# Access Compliance Report

## Public Rights-of-Way

### (Curb Ramps)

Intersection ID: 14659	Main Street: E_WORTHINGTON_AV	Cross Street: SPRINGDALE_AV	Location: E
ADA ID: F2463C026AFB	Ramp Type: Perp	Initial Pass/Fail: Fail	Overall Compliance: No
Severity Score: 12.5			
Codes/Mitigation Info/Possible Solution		Field Measurements/Component Compliance

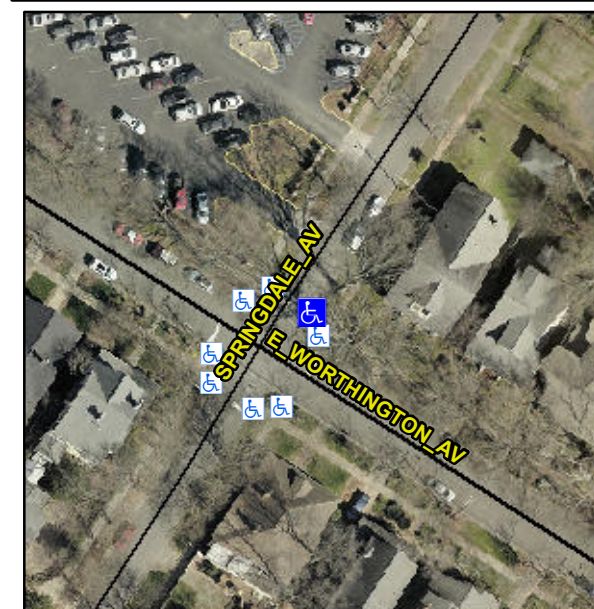
Compliance	Description	Data	Compliance	Description	Data
N/A	Ramp Length (in)	78.0	No	Ramp Slope (%)	8.4
Yes	Ramp Width (in)	59.0	Yes	Ramp XSlope (%)	2.0
N/A	Flare Type LT	N/A	N/A	Flare Type RT	N/A
N/A	Flare Slope LT (%)	N/A	N/A	Flare Slope RT (%)	N/A
N/A	Flare Traversable LT?	N/A	N/A	Flare Traversable RT?	N/A
N/A	Landing Length (in)	N/A	N/A	DWS Provided?	N/A
N/A	Landing Width (in)	N/A	N/A	DWS Contrast?	N/A
N/A	Landing Slope (%)	N/A	N/A	DWS Length (in)	N/A
N/A	Landing X Slope (%)	N/A	N/A	DWS Full Width?	N/A
N/A	Landing Curb? (Y/N)	N/A	N/A	DWS Offset (in)	N/A
N/A	Shared Landing?	N/A			
N/A	Gutter Ponding?	Yes	N/A	Gutter Slope (%)	N/A
N/A	Gutter Lip Ht (in)	N/A	N/A	Gutter X Slope (%)	N/A
N/A	Painted X Walk1?	No	N/A	Painted X Walk2?	N/A
	X Walk 1 Direction	To NW		X Walk 2 Direction	N/A
N/A	X Walk 1 Width (in)	N/A	N/A	X Walk 2 Width (in)	N/A
	X Walk 1 Slope (%)	3.0		X Walk 2 Slope (%)	N/A
	X Walk 1 X Slope (%)	1.0		X Walk 2 X Slope (%)	N/A

**Remove & Replace Entire Ramp.**

**R304.2.2**
